CITY OF PUEBLO, COLORADO

ADDENDUM NO. 3

PROJECT NO. 17-005 (CI1703)

Outlook Blvd. & Wills Blvd. Street & Storm Sewer Construction

SHEET 11 OF 11

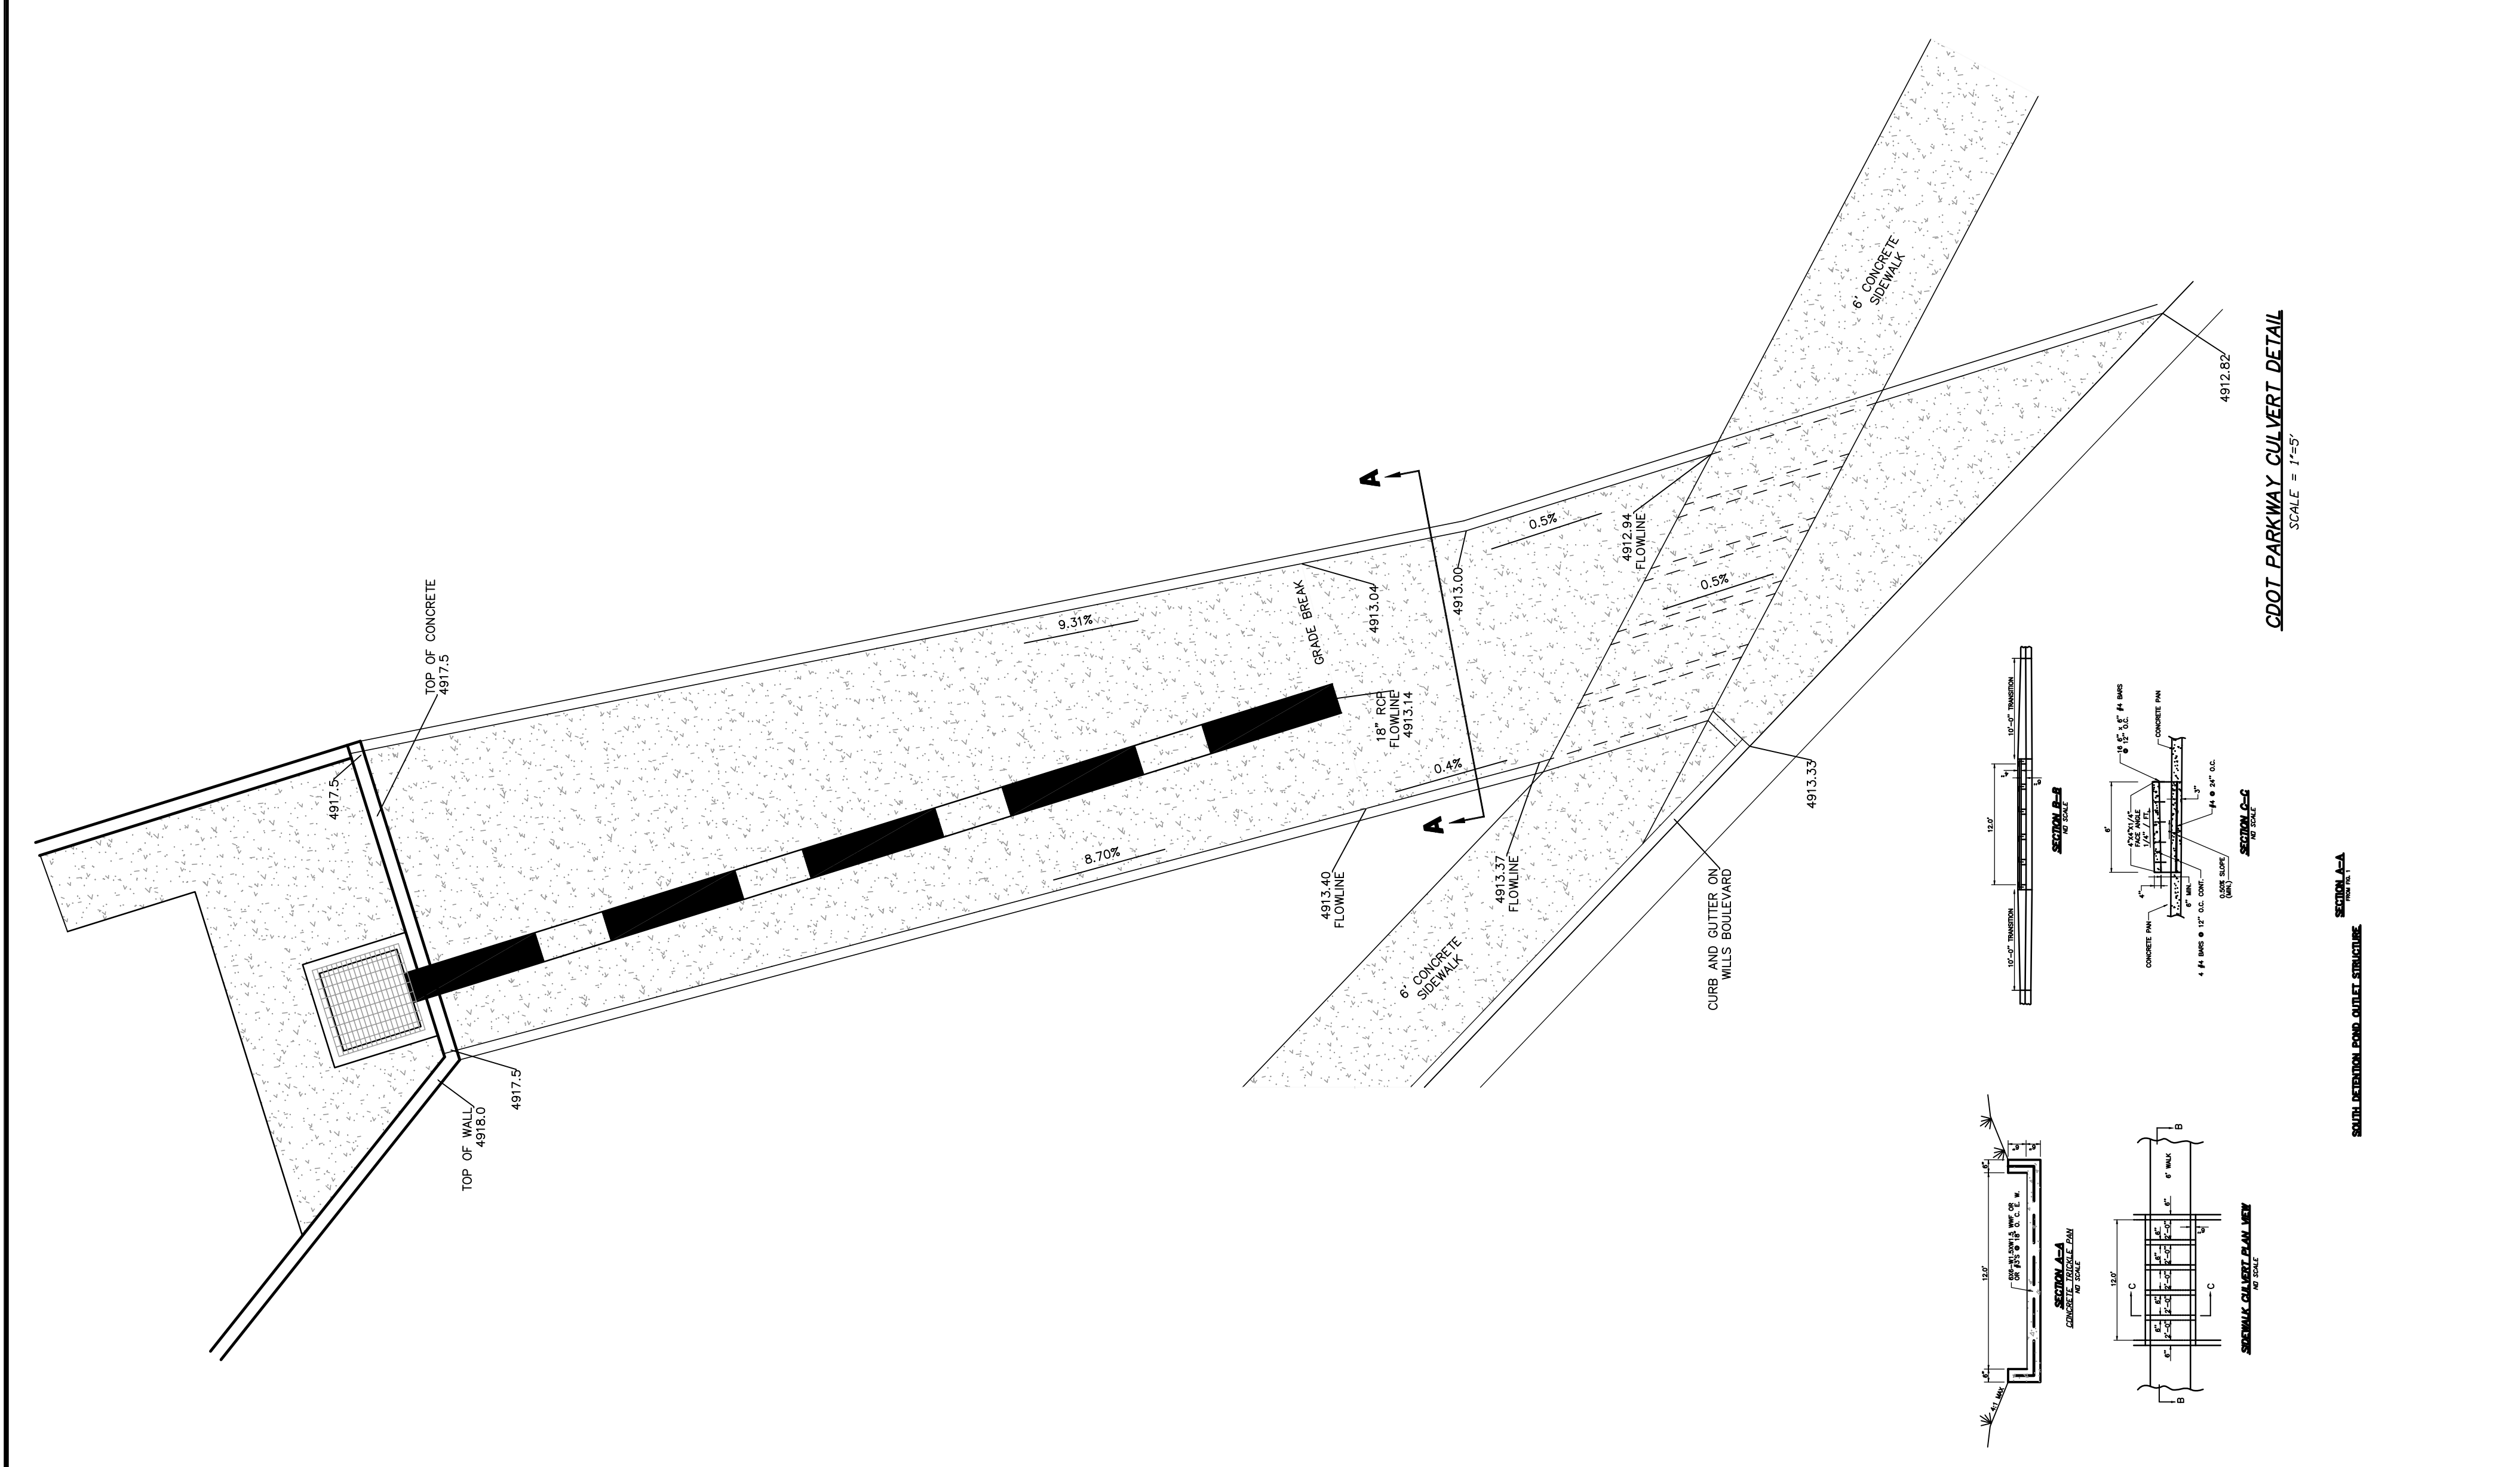
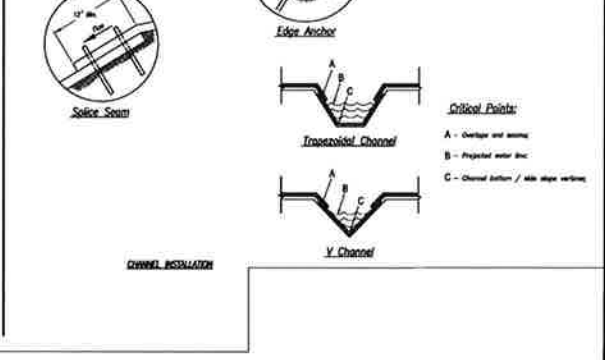
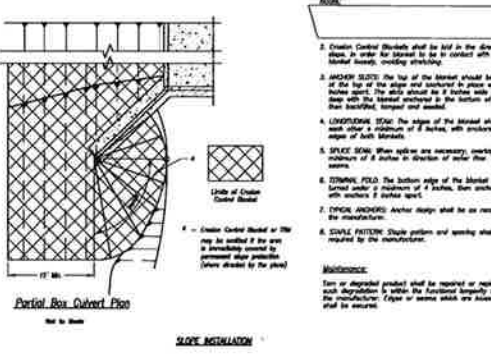
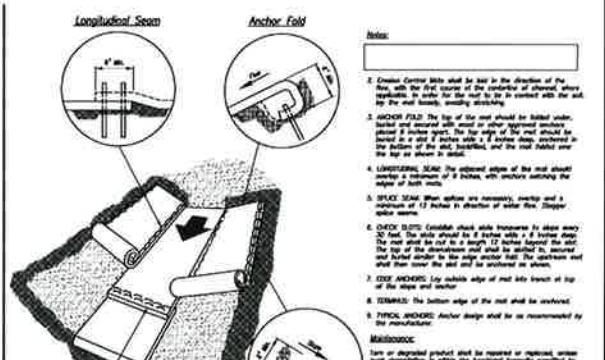
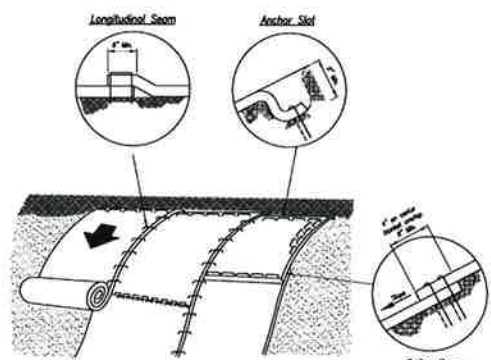
Q17. Will erosion control blankets be required along the 1:1 slope in Add Alternate No. 1.

Response: Yes, erosion control blankets will be required per the detail shown on plan sheet 11 of 11.
